NLS2005090
October 12, 2005

Subject: License Amendment Request to Revise Technical Specification Figures 3.4.9-1, 3.4.9-2, and 3.4.9-3 to Replace Cycle Restriction with Effective Full Power Year Limitation
Cooper Nuclear Station, Docket No. 50-298, DPR-46

Cooper Nuclear Station, NRC Docket 50-298, DPR-46

Figure 3.4.9-1 (page 1 of 1)
Pressure/Temperature Limits for
Non-Nuclear Heatup or Cooldown Following Nuclear Shutdown
Valid Through ~~End of Cycle 28~~

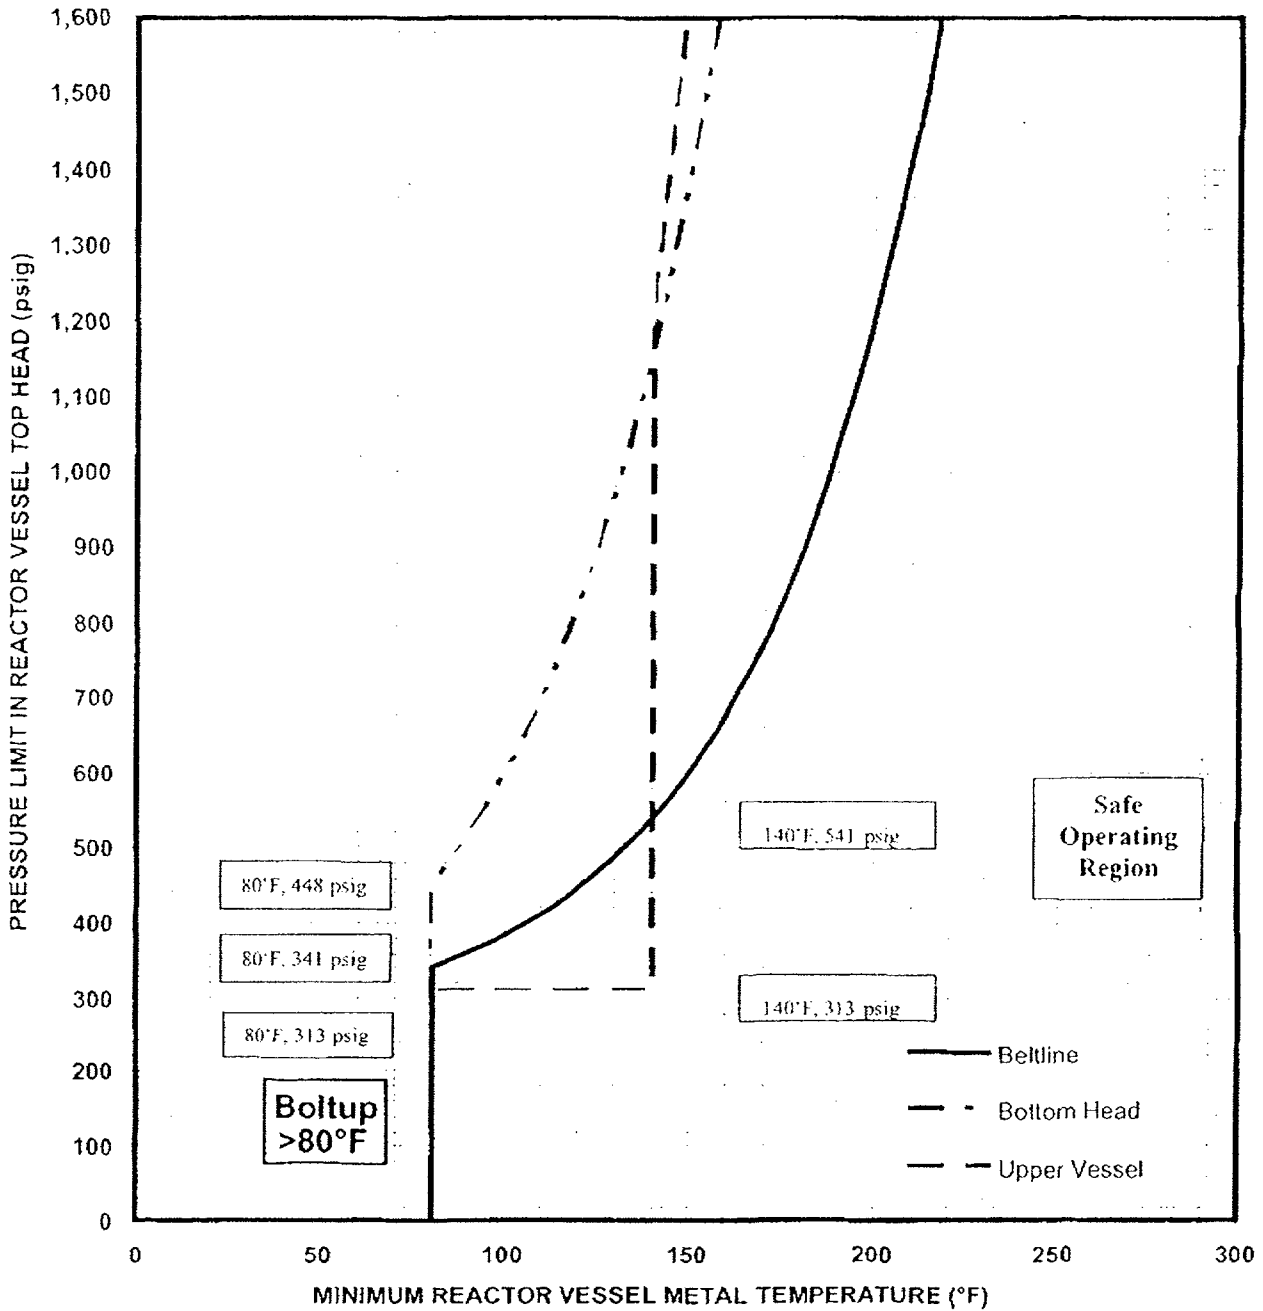
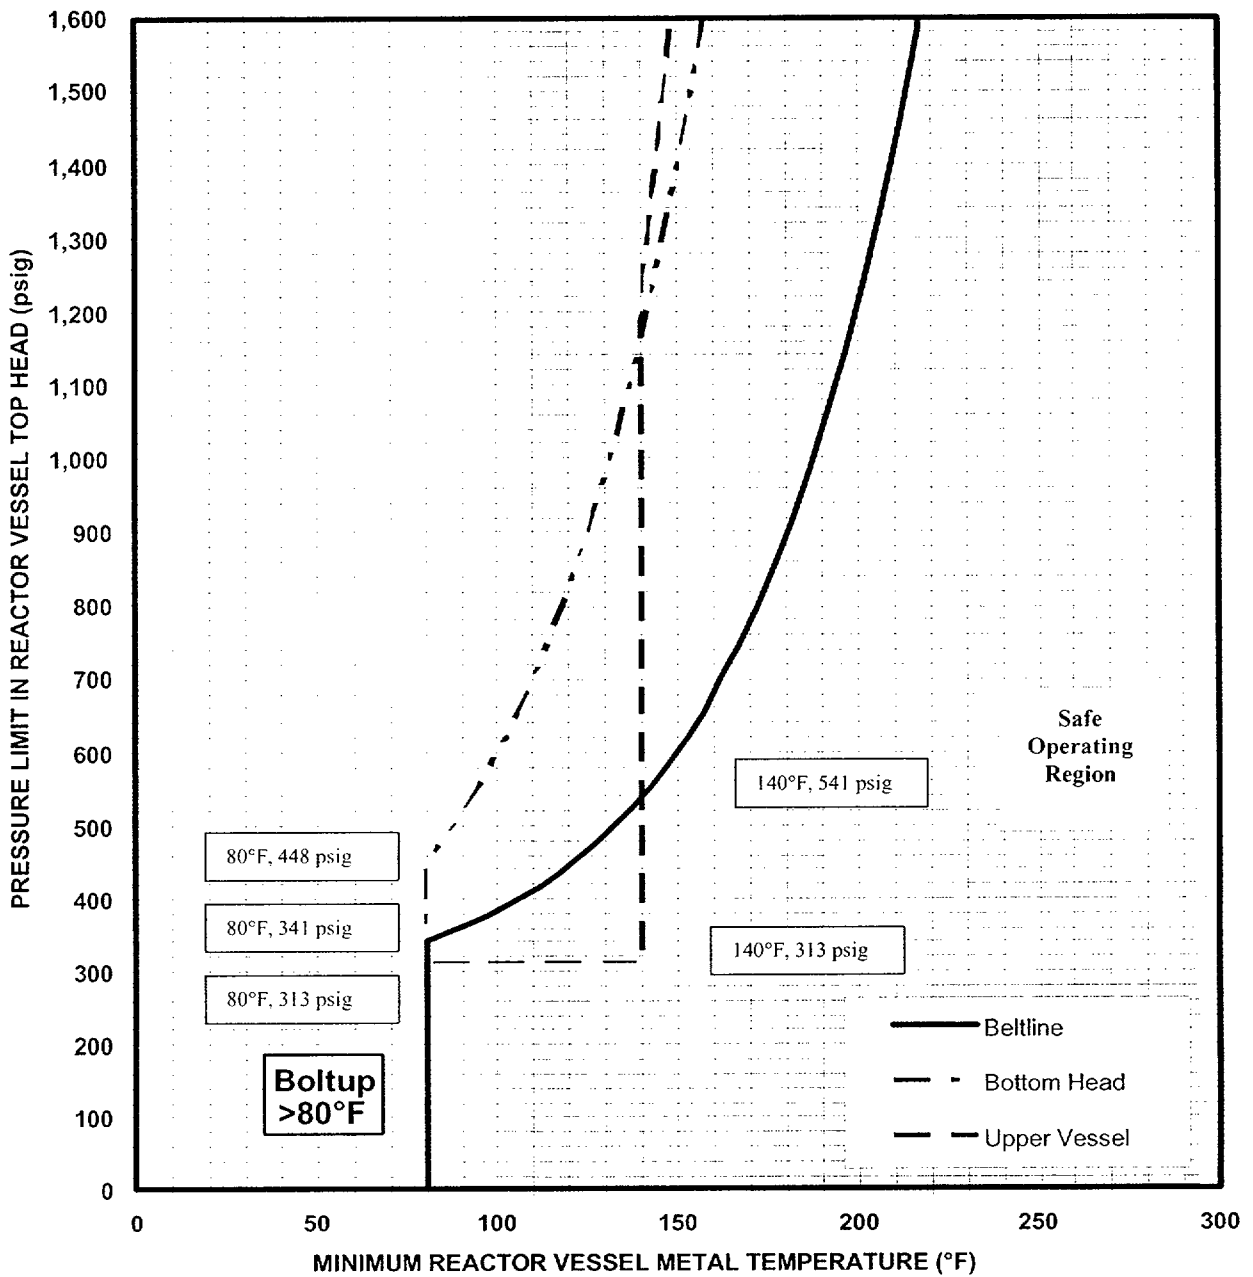
1. On TS Figure 3.4.9-1, "Pressure/Temperature Limits for Non-Nuclear Heatup or Cooldown Following Nuclear Shutdown, 32 EFPY," in the title change "32" to "30" and at the bottom change "End of Cycle 23" to "30 EFPY."
2. On TS Figure 3.4.9-2, "Pressure/Temperature Limits for Inservice Hydrostatic and Inservice Leakage Tests," in the title change "32" to "30" and at the bottom change "End of Cycle 23" to "30 EFPY."
3. On TS Figure 3.4.9-3 "Pressure/Temperature Limits for Criticality," in the title change "32" to "30" and at the bottom change "End of Cycle 23" to "30 EFPY."

The maximum beltline fluence calculated in NEDC 05-019 is slightly higher than the fluence used in the generation of the current P/T curves. Therefore, the P/T curves should be limited to 30 EFPY: $[(1.57\text{E}18 \text{ n}/\text{cm}^2)/(1.67\text{E}18 \text{ n}/\text{cm}^2)* 32 \text{ EFPY}] = 30.1 \text{ EFPY}$.

The "End of Cycle 23" limitation on the existing P/T curves in the TS may be removed and replaced with a limit of 30 EFPY. 30 EFPY is conservative because it is less than the 30.1 EFPY in the calculation.

³⁰EFPY

Valid Through 30 EFY
